#	Date	Source	Name	Comment
1.	9/2/2025	Email	Randy M., PE, PTOE	<p>Just read your supplement....a couple things to think about.</p> <ol style="list-style-type: none">1. 25B-RW-01 and 25B-MKG-01 both are being reviewed by sponsors addressing lane drop and lane reduction issues - fyi (see attached)2. Working with OSU we did some research on the stop line in advance of a marked crosswalk at a signal (see attached) - this is in review at TRB for potential presentation at the 2026 annual meeting3. 24A-PED-02 was approved by council related to Section 4F.19 and pedestrian change interval (attached)4. 25A-RW-01 addressed school when flashing and was approved by Council June 2025 (see attached) <p>Randy [see attachments]</p>
Follow-up	9/15/2025	Email	Randy M., PE, PTOE	<p>Hi Eric -</p> <p>Hope you are doing well. I have attached my comments to the draft Oregon Supplement to the MUTCD. It focuses on the removal of the colored LRT signal indications (which were a part of the 2009 supplement). I understand the situation that FHWA has created for ODOT and this topic but felt it was important to comment. Safety issues of this type should not be taken simply as compliance issues unless research

Figure 3B-10. Examples of Dotted Line and Channelizing Line Applications for Entrance Ramp Markings (Sheet 1 of 2)

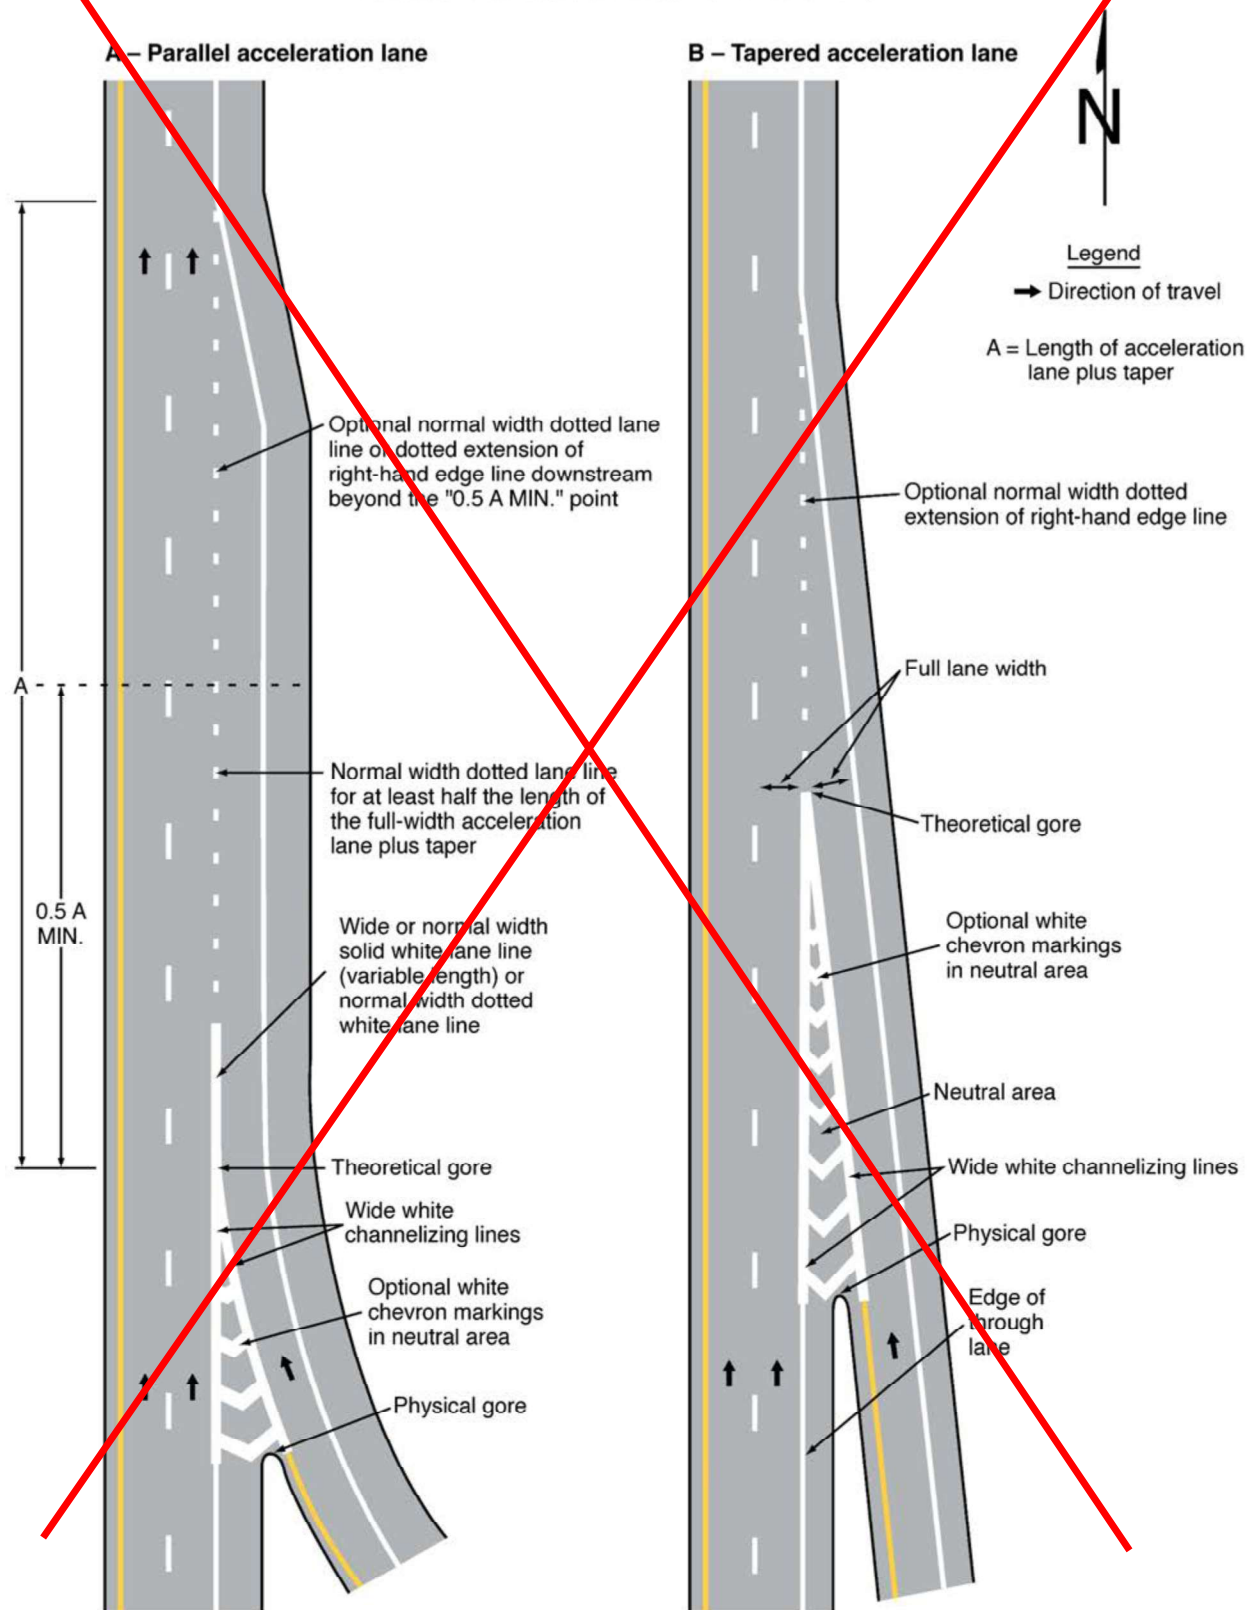
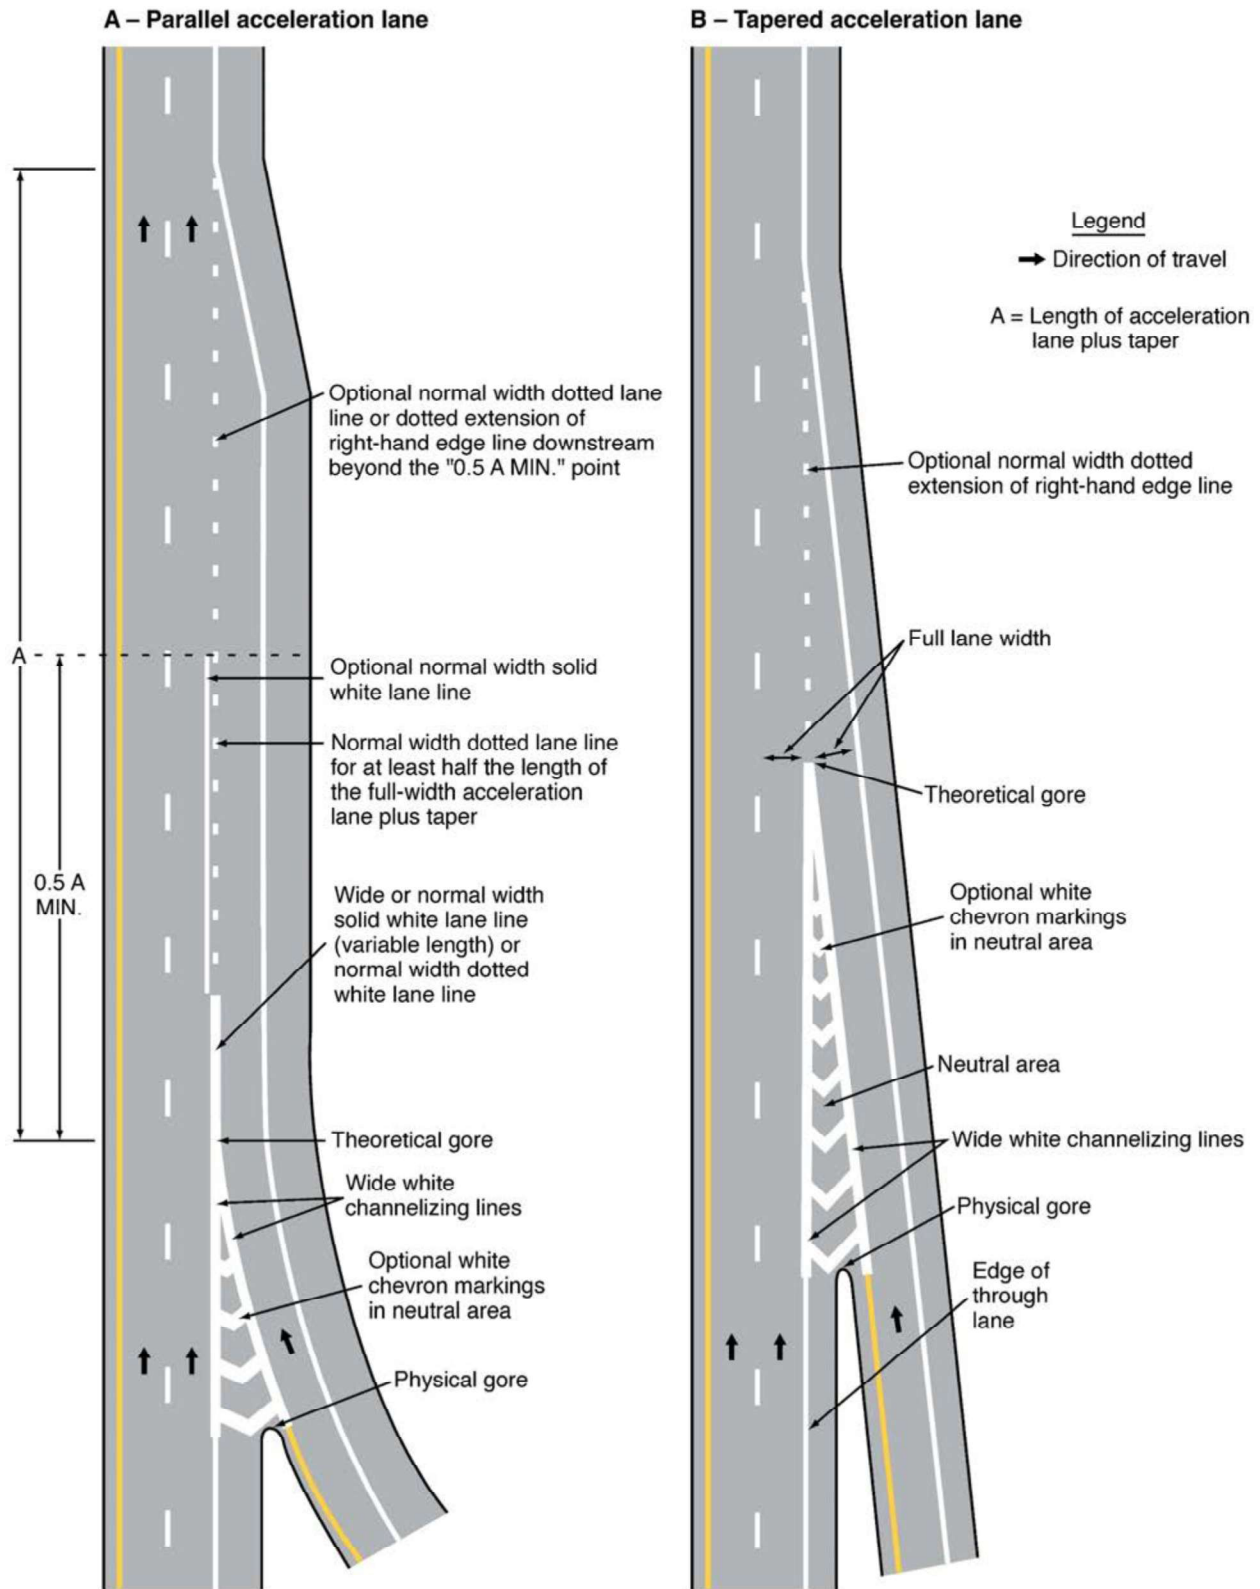
04a For entrance ramps with a parallel acceleration lane, a double white line consisting of a normal width solid white line adjacent to traffic traveling in the continuing lane, and a normal width dotted white lane line adjacent to traffic traveling in the acceleration lane, may be installed from the theoretical gore or from the downstream end of a solid white lane line, if used, that extends downstream from the theoretical gore, to a point at least one-half the distance from the theoretical gore to the upstream end of the acceleration taper, as shown in Drawing A in Figure 3B-10.

Figure 3B-14. Examples of Applications of Lane-Reduction Transition Markings

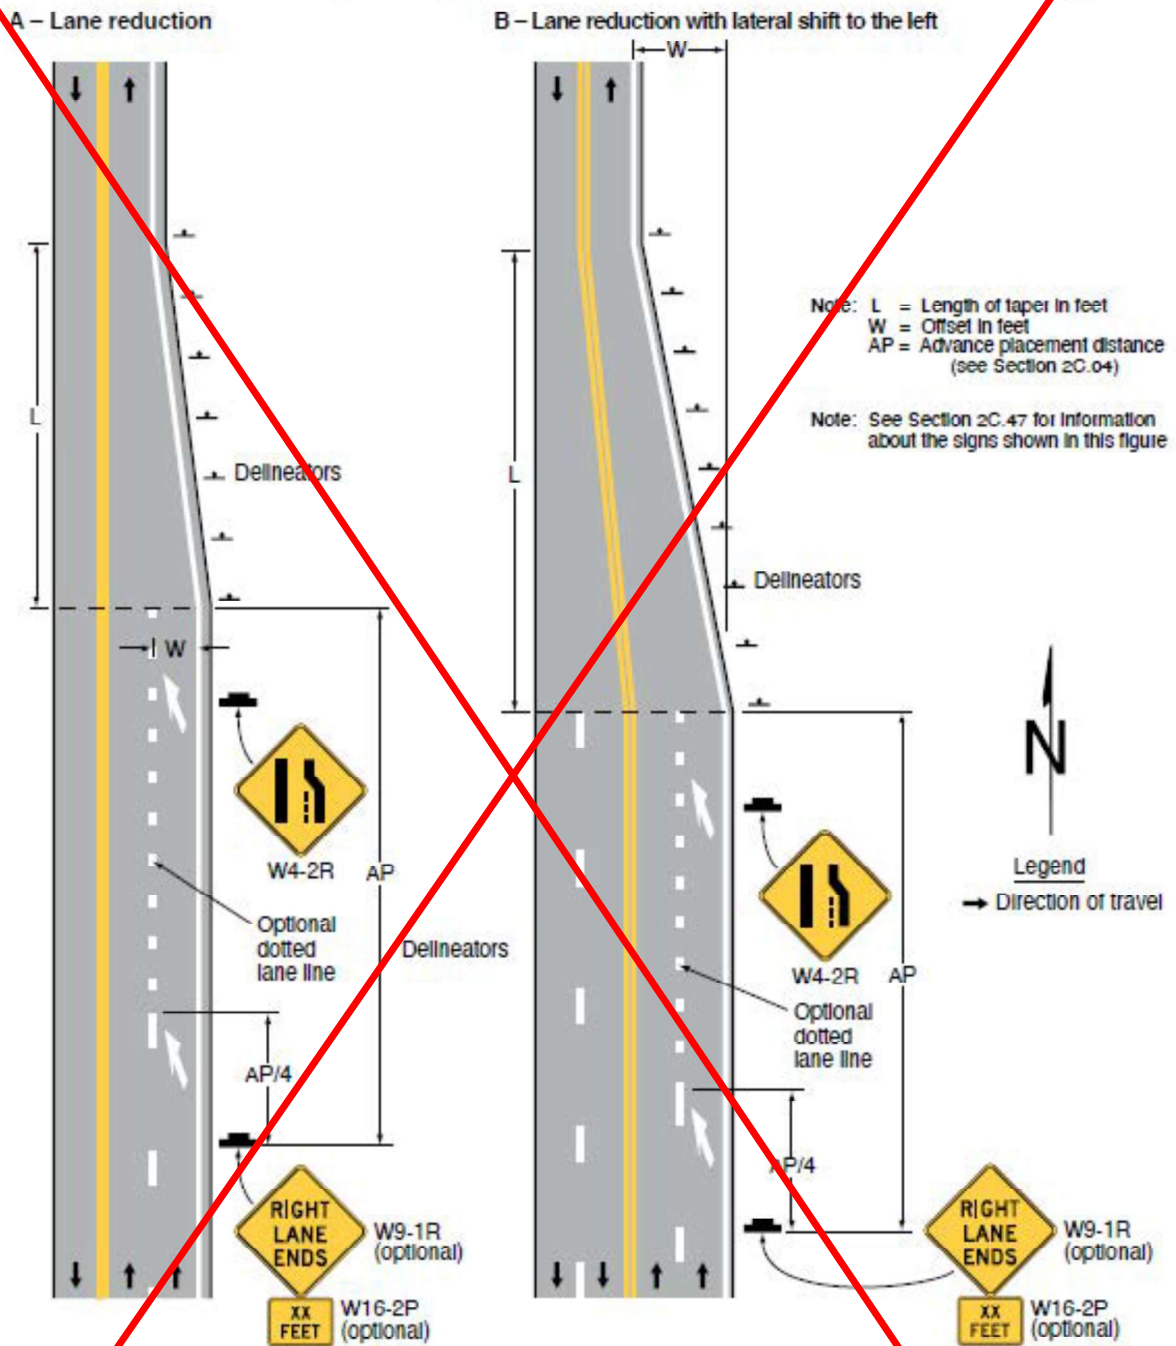
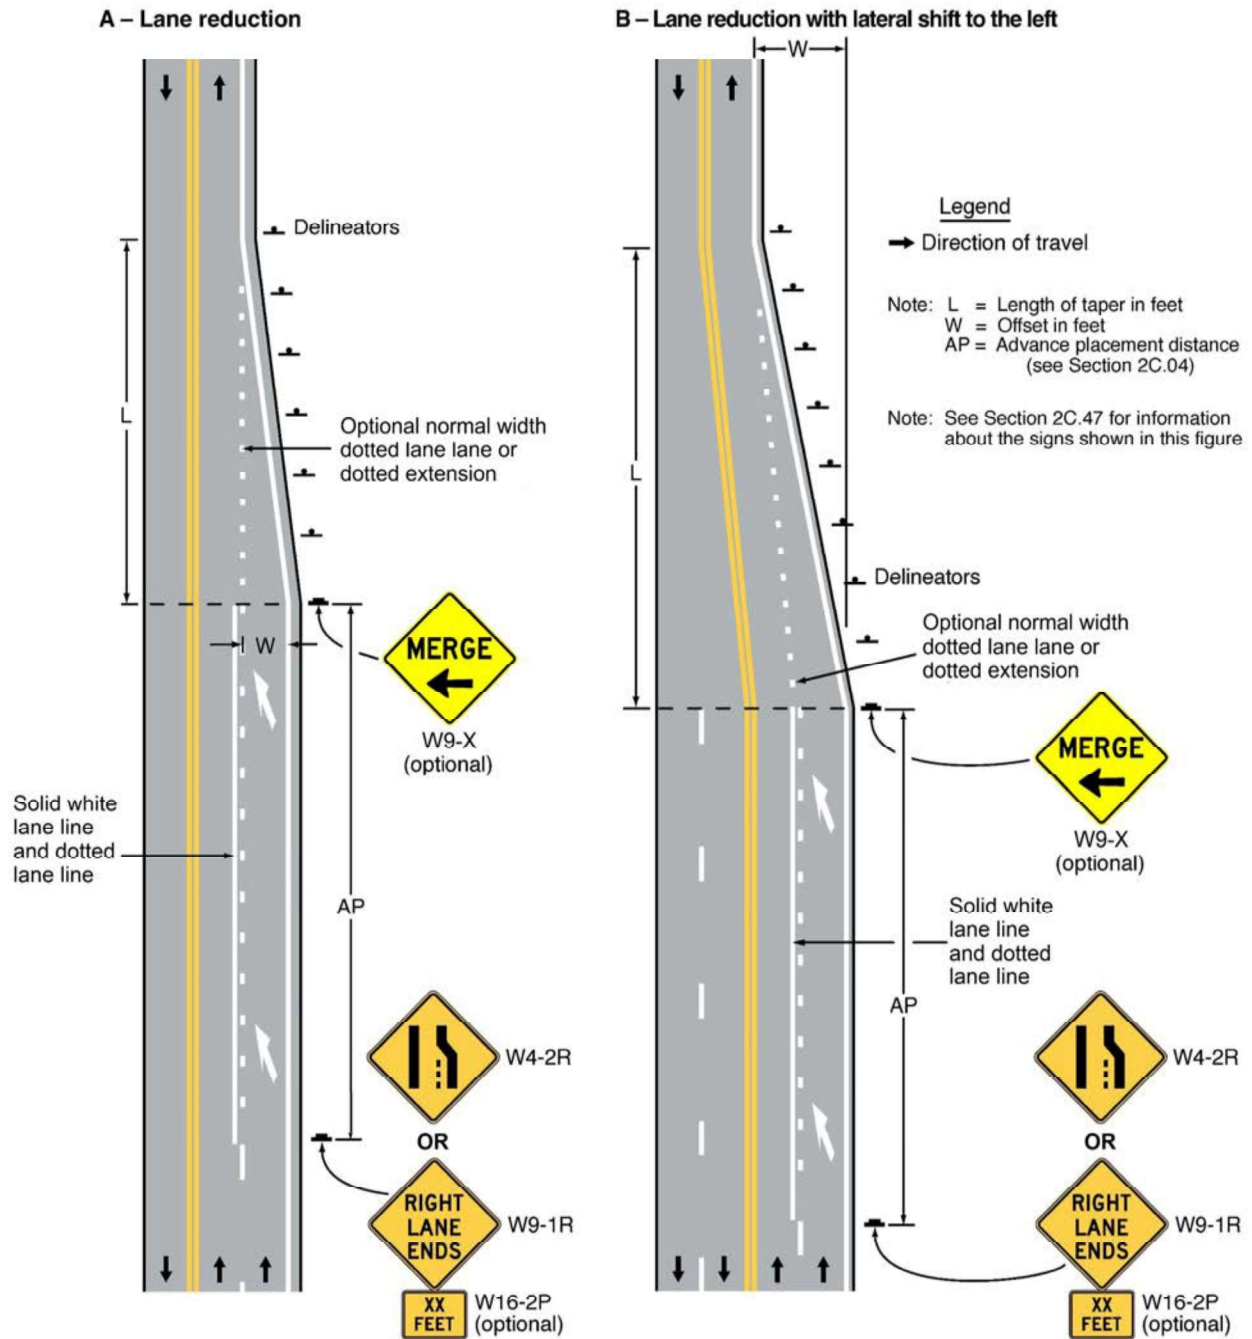
262 ~~16 A dotted white line may be used between the point where the broken white lane line is terminated to~~
263 ~~the point where the transition taper begins.~~ [Text included as part of Paragraph 07 Part D and
264 changed from a "may" to a "should" condition]

Figure 2B-16. Example of Application of Regulatory Signing and Pavement Markings at an Entrance Ramp Terminal

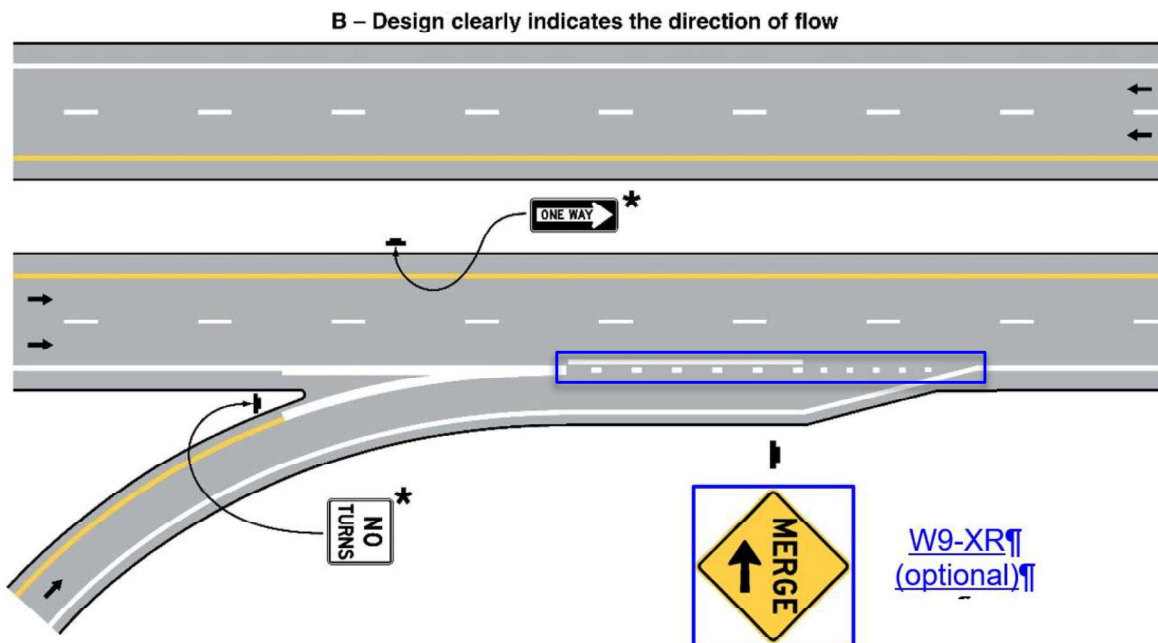
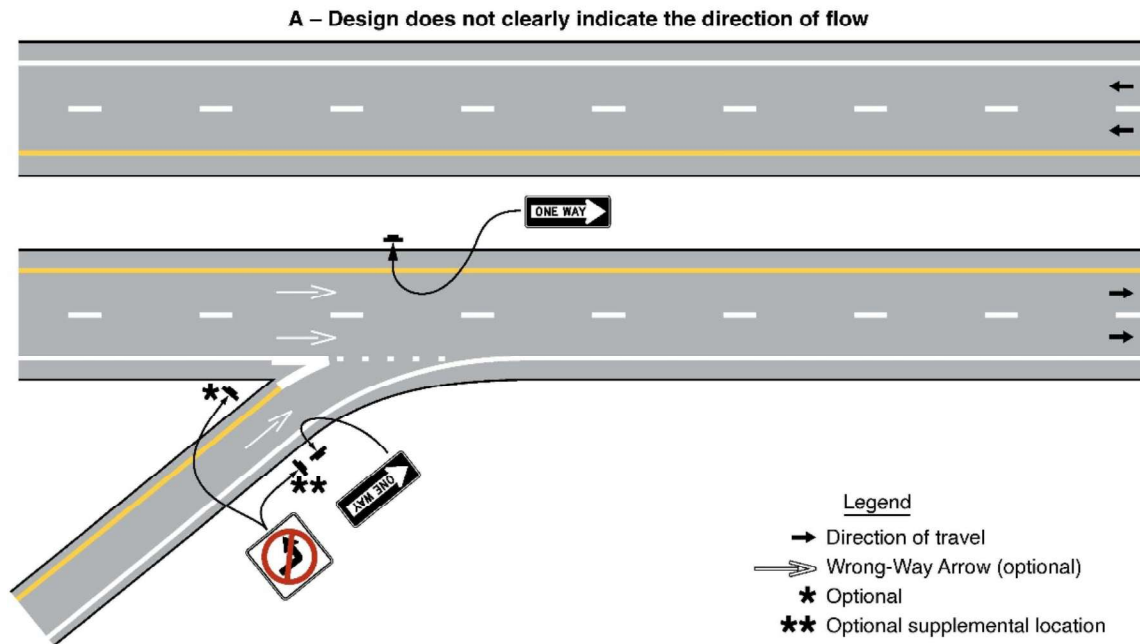
1. Add Optional W9-X MERGE WITH ARROW sign at beginning of taper.
2. Interim depiction of pavement marking patterns and lane reduction arrows reflect existing content in the MUTCD that is harmonized with research results with the addition of the solid line consistent with the research report. These depictions are subject to change pending Council approval of the MTC proposal addressing this research.

Figure 2C-11. Merging and Passing Signs and Plaques

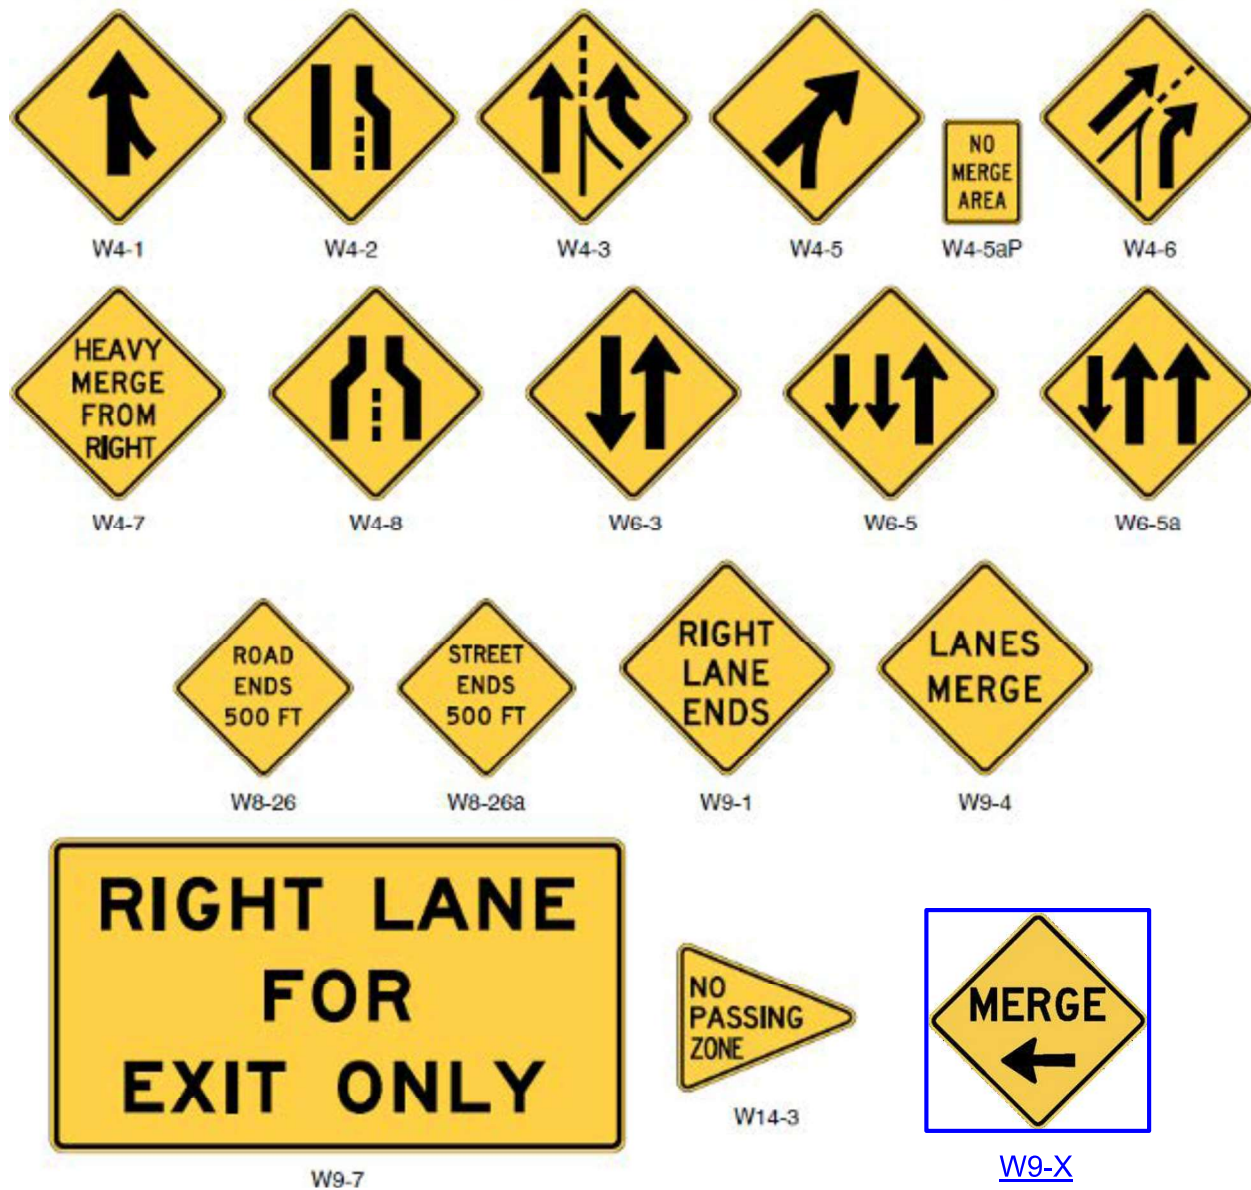
1. Added W9-X MERGE with arrow sign, recommending W9-2 designation
